# Access Compliance Report

## Public Rights-of-Way

### (Curb Ramps)

Intersection ID: 29237	Main Street: TESSERA_DR	Cross Street: WOODINGTON_LN	Location: NE
ADA ID: 30F01F2696C5	Ramp Type: BlendTrans1	Initial Pass/Fail: Fail	Overall Compliance: No
Severity Score: 10			
Codes/Mitigation Info/Possible Solution		Field Measurements/Component Compliance

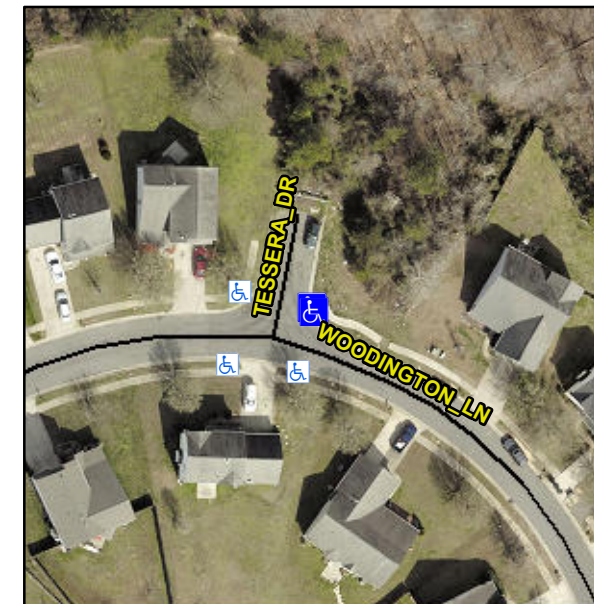
**R304.5.1, R304.5.3**

Compliance	Description	Data	Compliance	Description	Data
N/A	Ramp Length (in)	47.0	Yes	BlendTrans Slope (%)	1.2
No	Ramp Width (in)	45.0	No	BlendTrans XSlope (%)	2.2
N/A	Flare Type LT	N/A	N/A	Flare Type RT	N/A
N/A	Flare Slope LT (%)	N/A	N/A	Flare Slope RT (%)	N/A
N/A	Flare Traversable LT?	N/A	N/A	Flare Traversable RT?	N/A
N/A	Landing Length (in)	N/A	N/A	DWS Provided?	N/A
N/A	Landing Width (in)	N/A	N/A	DWS Contrast?	N/A
N/A	Landing Slope (%)	N/A	N/A	DWS Length (in)	N/A
N/A	Landing X Slope (%)	N/A	N/A	DWS Full Width?	N/A
N/A	Landing Curb? (Y/N)	N/A	N/A	DWS Offset (in)	N/A
N/A	Shared Landing?	N/A			
N/A	Gutter Ponding?	N/A	N/A	Gutter Slope (%)	N/A
N/A	Gutter Lip Ht (in)	N/A	N/A	Gutter X Slope (%)	N/A
N/A	Painted X Walk1?	No	N/A	Painted X Walk2?	No
	X Walk 1 Direction	To W		X Walk 2 Direction	To S
	X Walk 1 Width (in)	N/A		X Walk 2 Width (in)	N/A
	X Walk 1 Slope (%)	4.2		X Walk 2 Slope (%)	5.7
	X Walk 1 X Slope (%)	3.5		X Walk 2 X Slope (%)	2.7

**Remove & Replace Curb Ramp With Two New Directional Ramps or Equivalent.**
